**SUBJECT: ISSUANCE OF AMENDMENTS - VOGTLE ELECTRIC GENERATING PLANT,  
UNITS 1 AND 2 (TAC NOS. M99421 AND M99422)**

The amendments change VEGP TS 3.7.17, "Fuel Storage Pool Boron Concentration," TS 3.7.18, "Fuel Assembly Storage in the Fuel Storage Pool," and TS 4.3, "Fuel Storage," to credit soluble boron in the spent fuel pool for maintenance of subcriticality associated with spent fuel storage.

SAFETY EVALUATION BY THE OFFICE OF NUCLEAR REACTOR REGULATION  
RELATED TO AMENDMENT NO. 99 TO FACILITY OPERATING LICENSE NPF-68  
AND AMENDMENT NO. 77 TO FACILITY OPERATING LICENSE NPF-81  
SOUTHERN NUCLEAR OPERATING COMPANY, INC., ET AL.  
VOGTLE ELECTRIC GENERATING PLANT, UNITS 1 AND 2  
DOCKET NOS. 50-424 AND 50-425

Figure 3.7.18-1 Vogtle Unit 1 Burnup Credit Requirements for All Cell Storage

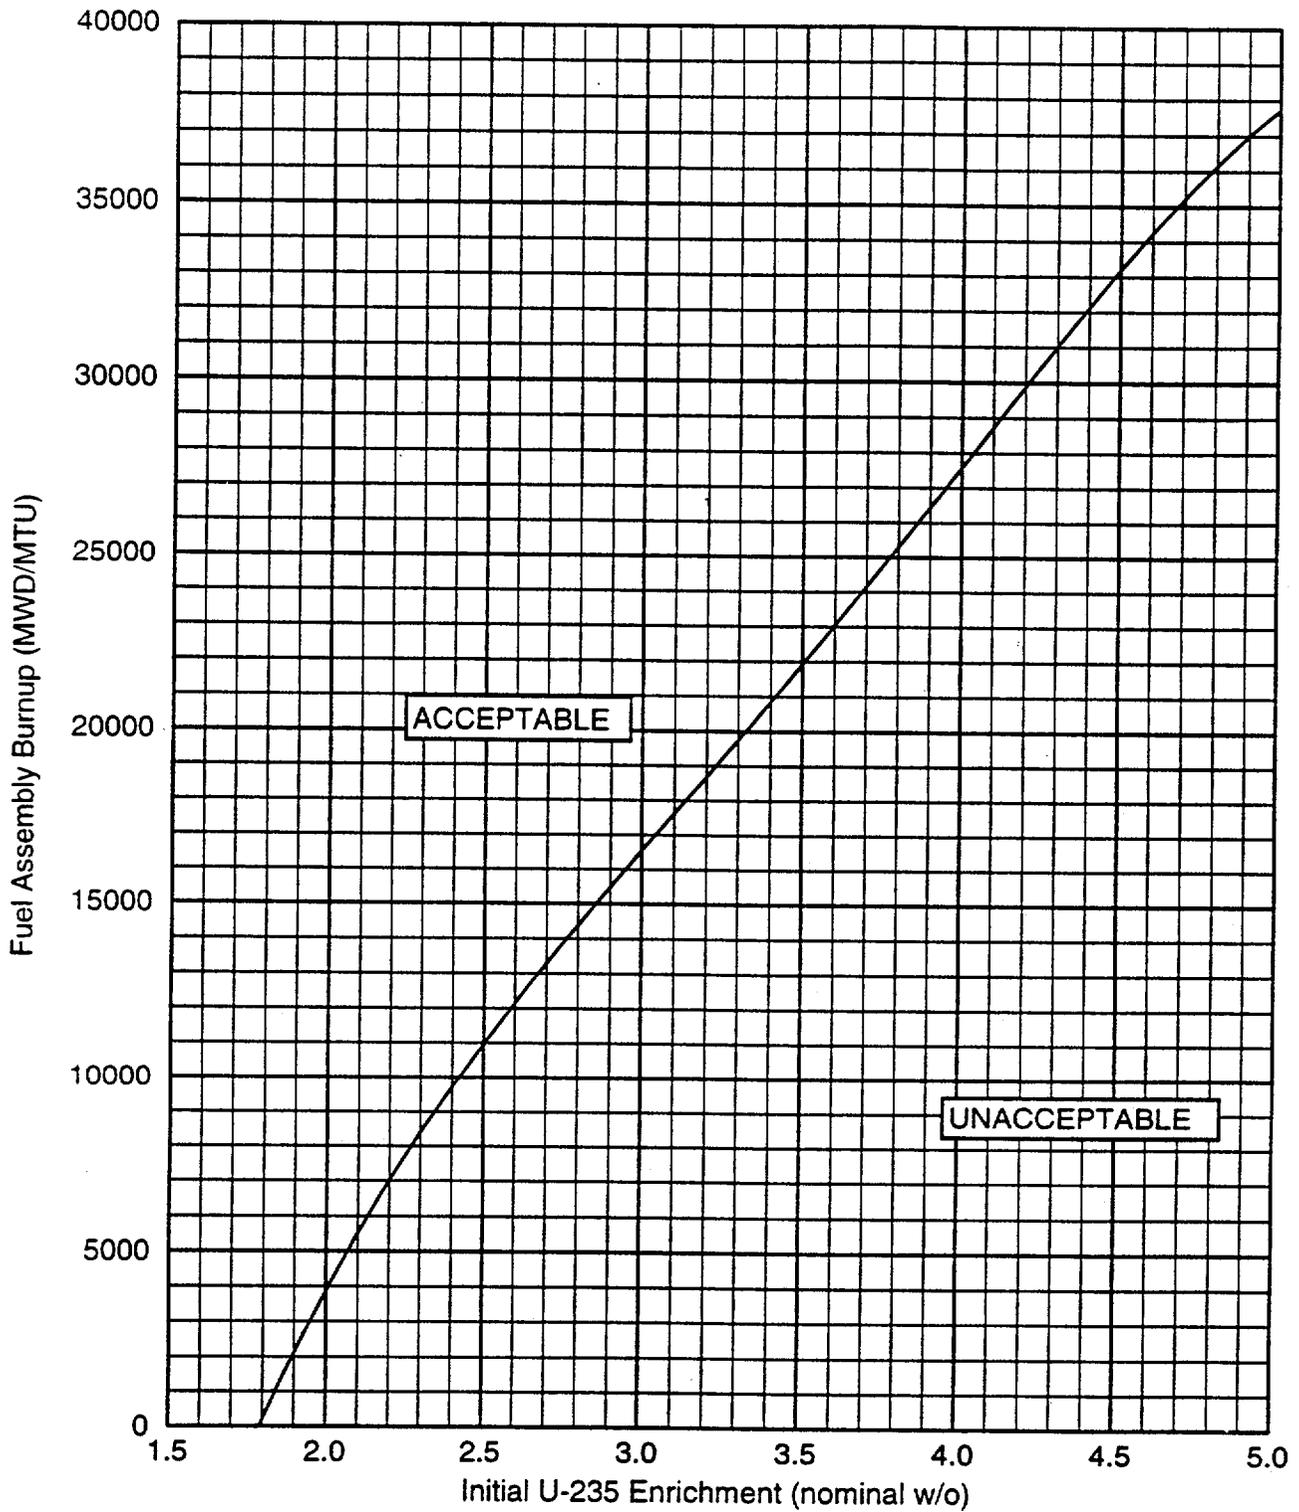
Assemblies with initial nominal enrichments no greater than 1.79 w/o U-235 can be stored in any cell location. Fuel assemblies with initial nominal enrichments greater than 1.79 w/o U-235 and up to 5.0 w/o U-235 must satisfy a minimum burnup requirement as shown in proposed TS Figure 3.7.18-1, "Vogtle Unit 1 Burnup Credit Requirements for All Cell Storage."

Figure 3.7.18-2 Vogtle Unit 2 Burnup Credit Requirements for All Cell Storage

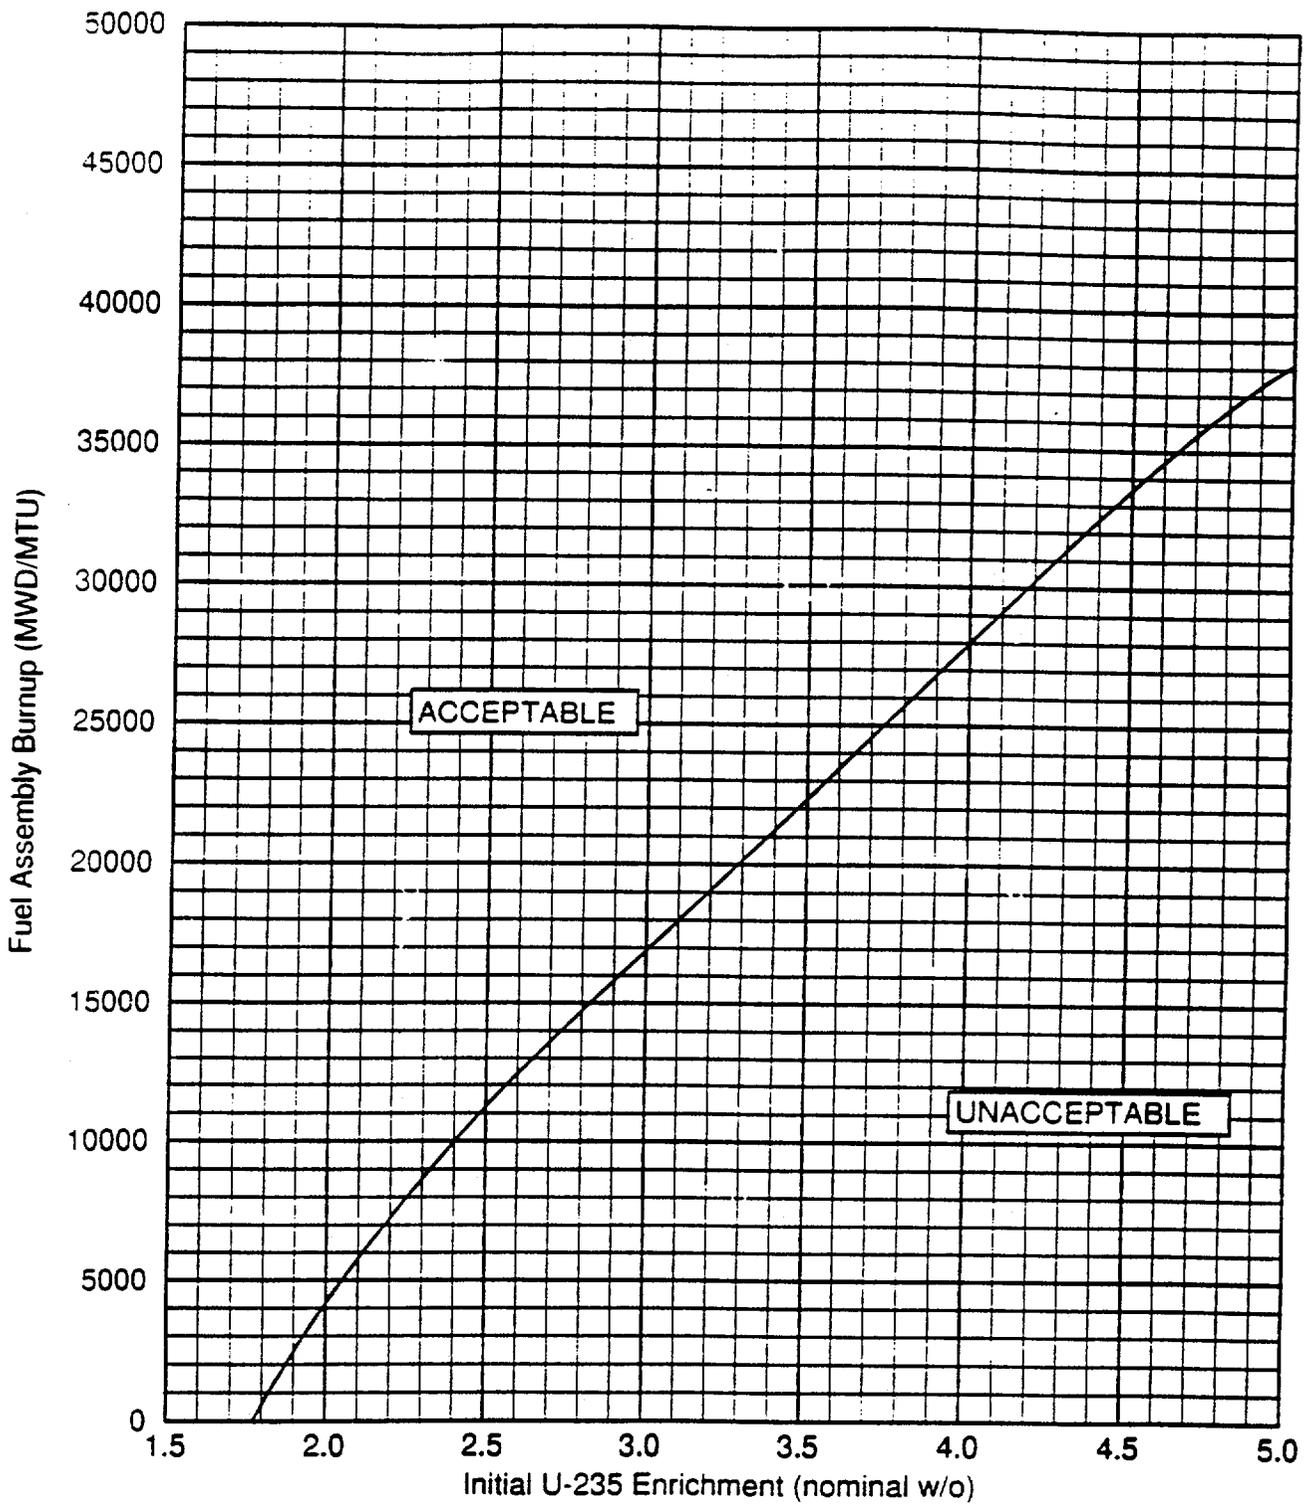
Assemblies with initial nominal enrichments no greater than 1.77 w/o U-235 can be stored in any cell location. Fuel assemblies with initial nominal enrichments greater than 1.77 w/o U-235 and up to 5.0 w/o U-235 must satisfy a minimum burnup requirement as shown in proposed TS Figure 3.7.18-2, "Vogtle Unit 2 Burnup Credit Requirements for All Cell Storage."

Figure 4.3.1-1 Vogtle Unit 1 Burnup Credit Requirements for 3-out-of-4 Storage

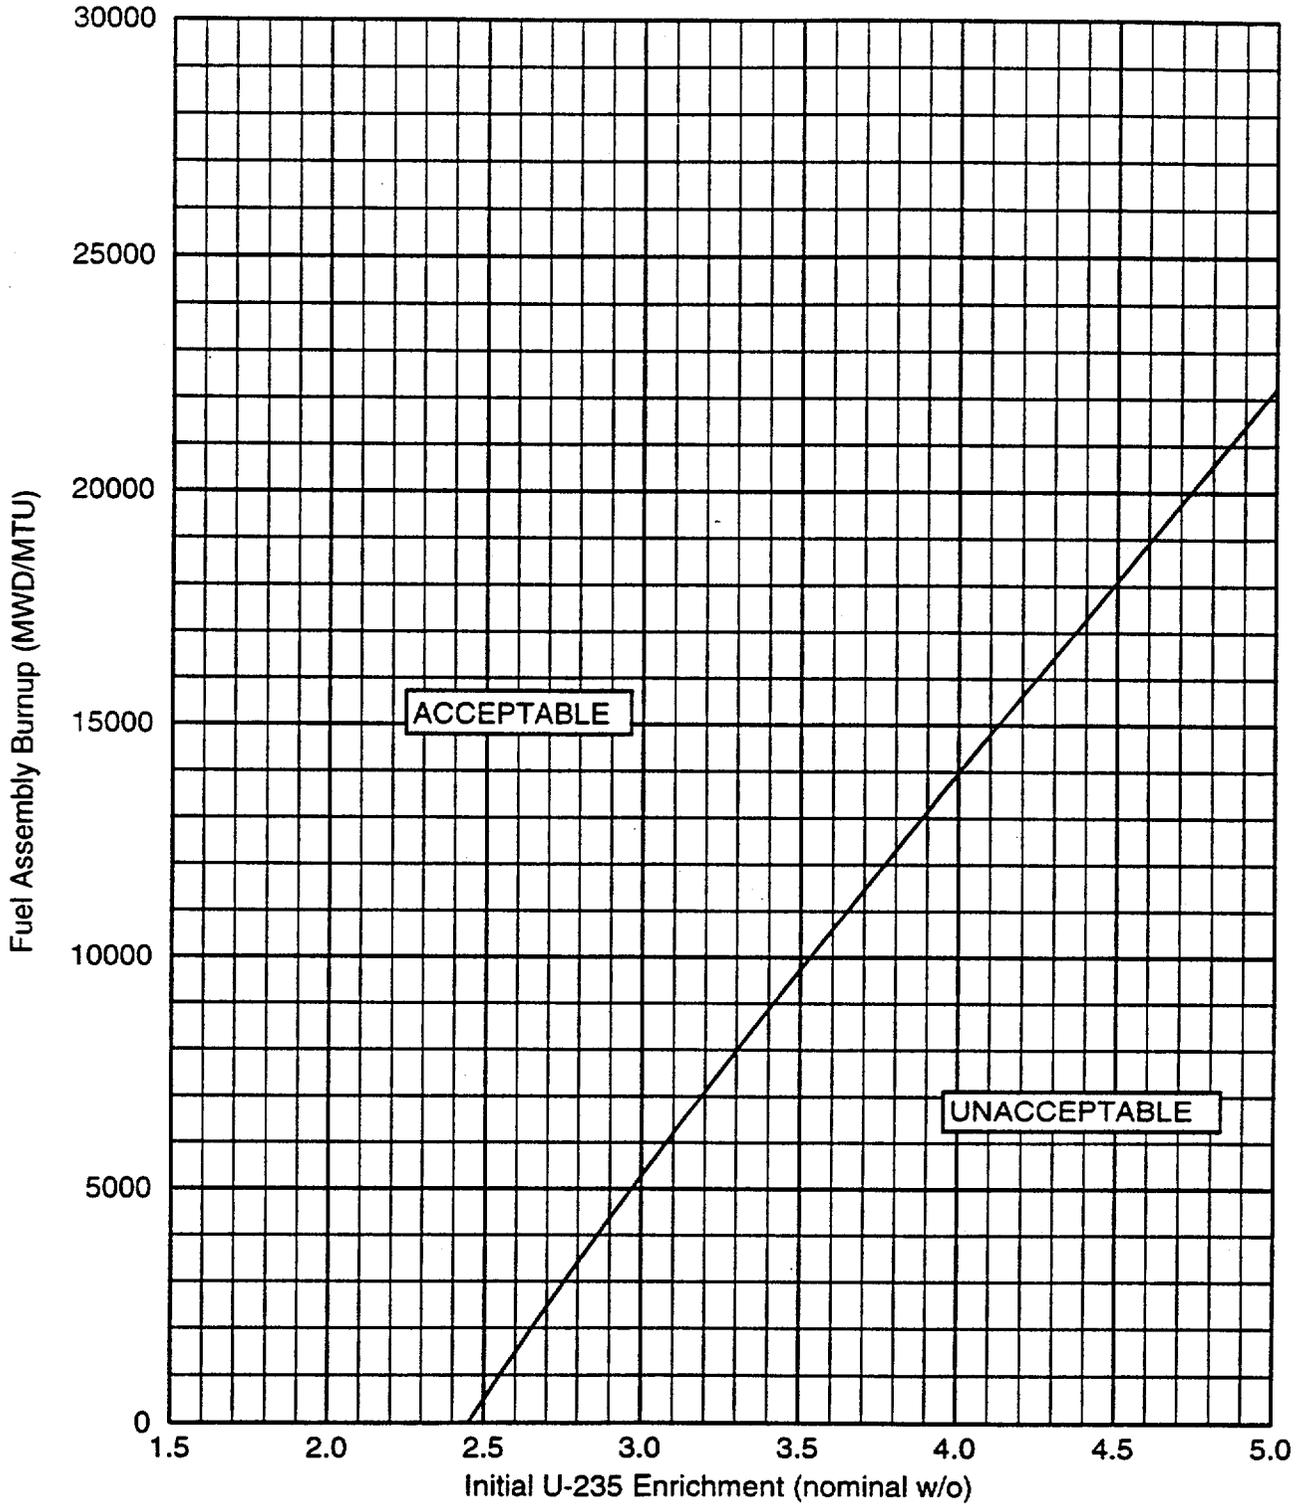
Assemblies with initial nominal enrichments no greater than 2.45 w/o U-235 can be stored in a 3-out-of-4 checkerboard arrangement. Fuel assemblies with initial nominal enrichments greater than 2.45 w/o U-235 and up to 5.0 w/o U-235 must satisfy a minimum burnup requirement as shown in proposed TS Figure 4.3.1-1, "Vogtle Unit 1 Burnup Credit Requirements for 3-out-of-4 Storage."

Figure 4.3.1-2 Vogtle Unit 2 Burnup Credit Requirements for 3-out-of-4 Storage

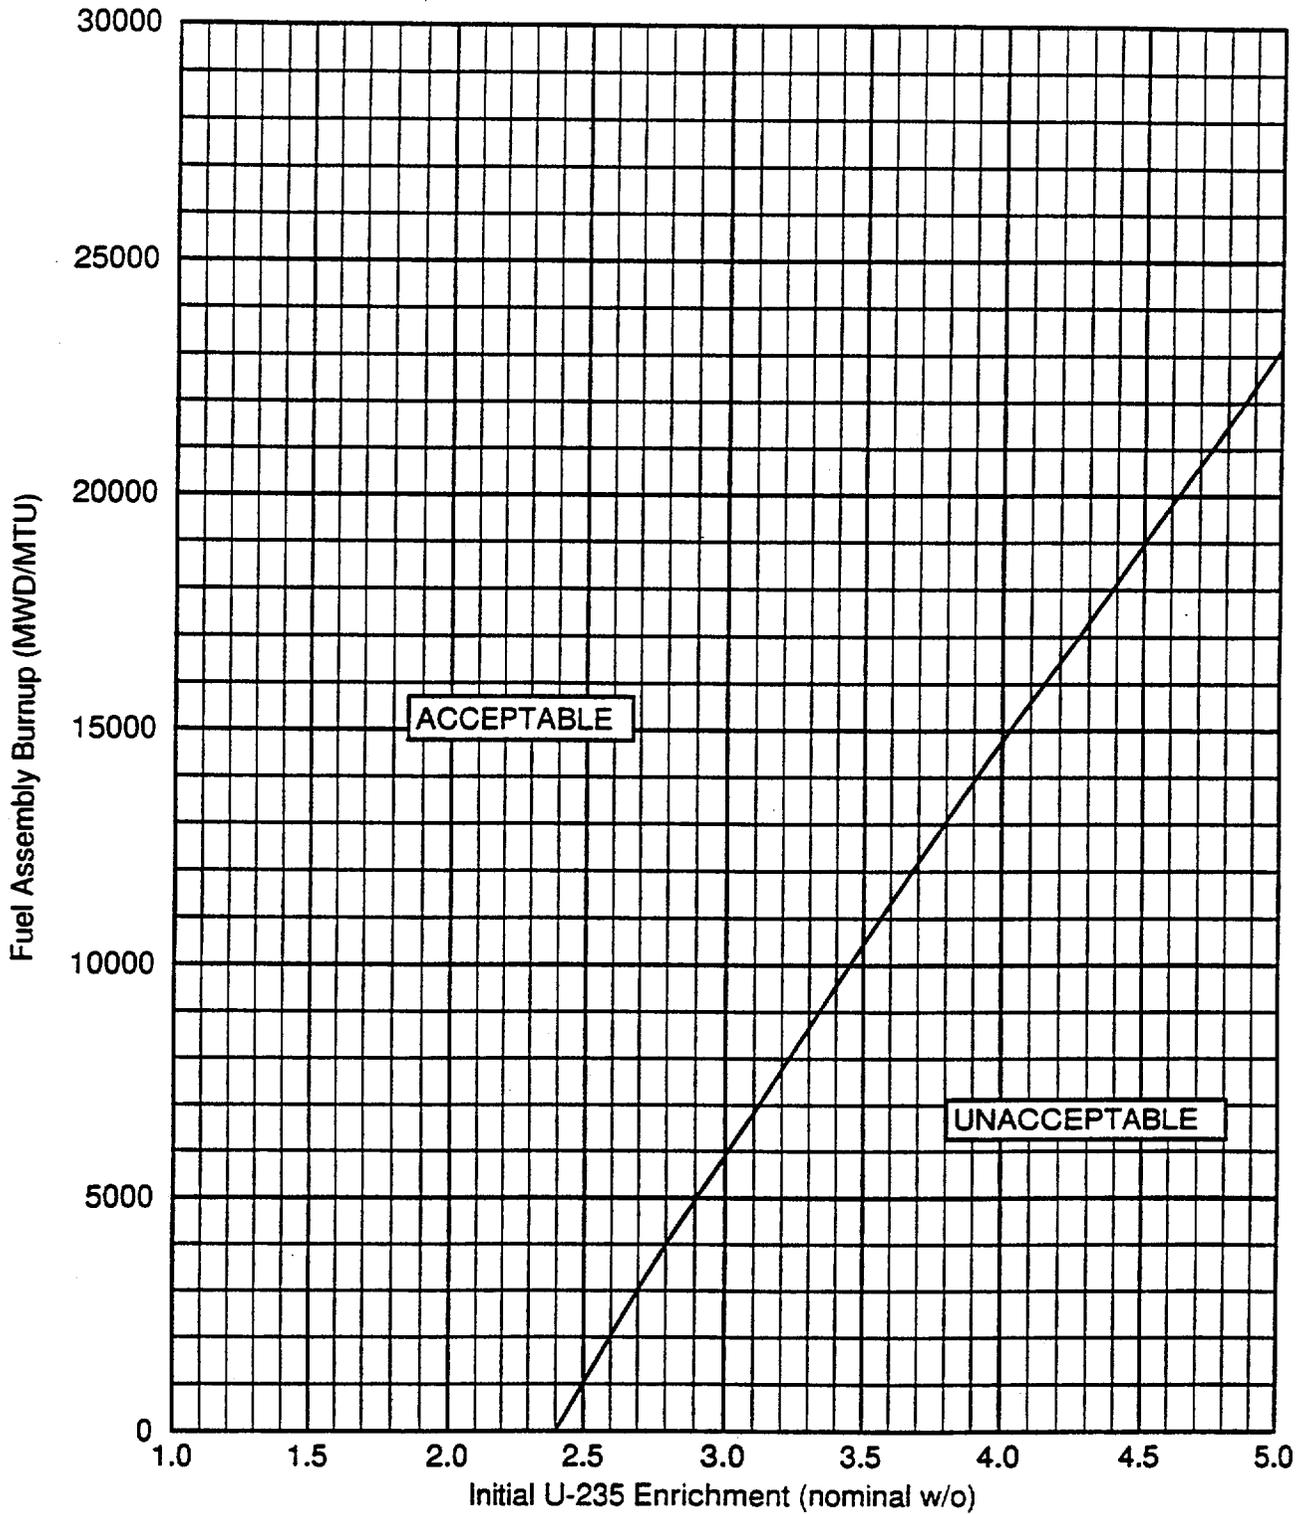
Assemblies with initial nominal enrichments no greater than 2.40 w/o U-235 can be stored in a 3-out-of-4 checkerboard arrangement as shown in proposed TS Figure 4.3.1-4. Fuel assemblies with initial nominal enrichments greater than 2.40 w/o U-235 and up to 5.0 w/o U-235 must satisfy a minimum burnup requirement as shown in proposed TS Figure 4.3.1-2, "Vogtle Unit 2 Burnup Credit Requirements for 3-out-of-4 Storage."

Figure 4.3.1-4 Vogtle Units 1 and 2 Empty Cell Checkerboard Storage Configurations

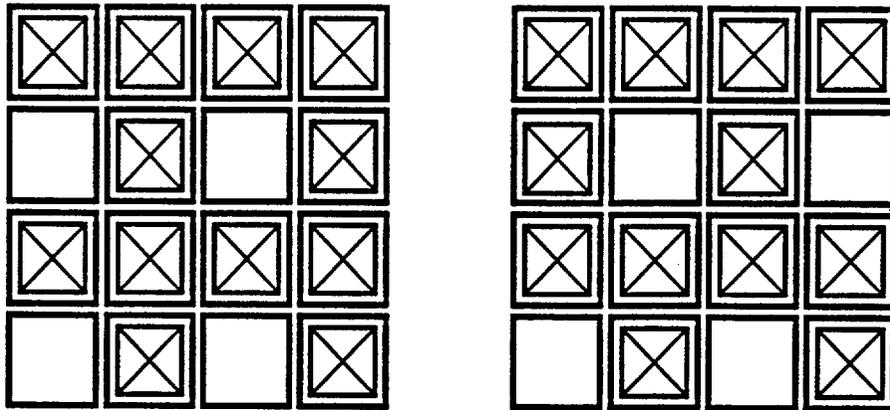
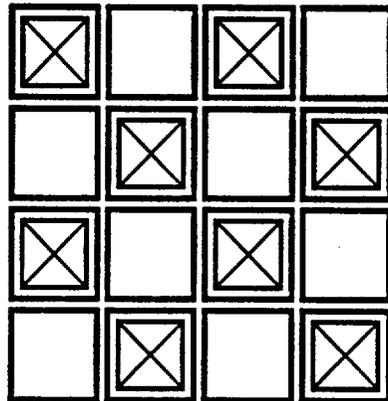
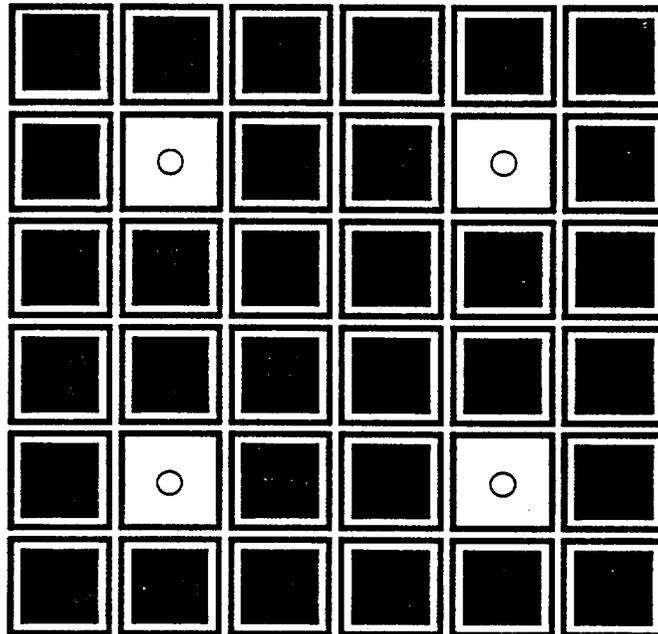
Assemblies with initial nominal enrichments no greater than 5.0 w/o U-235 can be stored in a 2-out-of-4 checkerboard arrangement as shown in proposed TS Figure 4.3.1-4, "Vogtle Units 1 and 2 Empty Cell Checkerboard Storage Configuration."

Assemblies with initial nominal enrichments no greater than 5.0 w/o U-235 can be stored in a 2-out-of-4 checkerboard arrangement as shown in proposed TS Figure 4.3.1-4.

Figure 4.3.1-6 Vogtle Units 1 and 2 Interface Requirements  
(All Cell to Checkerboard Storage)

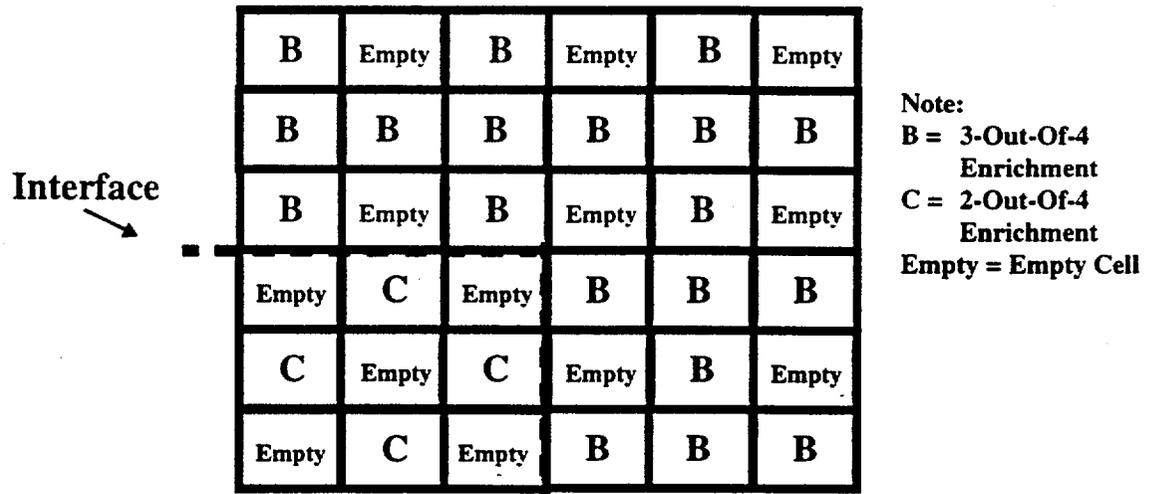
In order to prevent an undesirable increase in reactivity, the boundaries between the different storage configurations were analyzed. The interface requirements are shown in proposed TS Figures as follows: TS Figure 4.3.1-6, "Vogtle Units 1 and 2 Interface Requirements (All Cell to Checkerboard Storage)," TS Figure 4.3.1-7, "Vogtle Units 1 and 2 Interface Requirements (Checkerboard Storage Interface)," TS Figure 4.3.1-8, "Vogtle Unit 2 Interface Requirements (3x3 Checkerboard to All Cell Storage)," and TS Figure 4.3.1-9, "Vogtle Unit 2 Interface Requirements (3x3 to Empty Cell Checkerboard Storage)." These interface requirements are consistent with the criticality analysis and are acceptable.
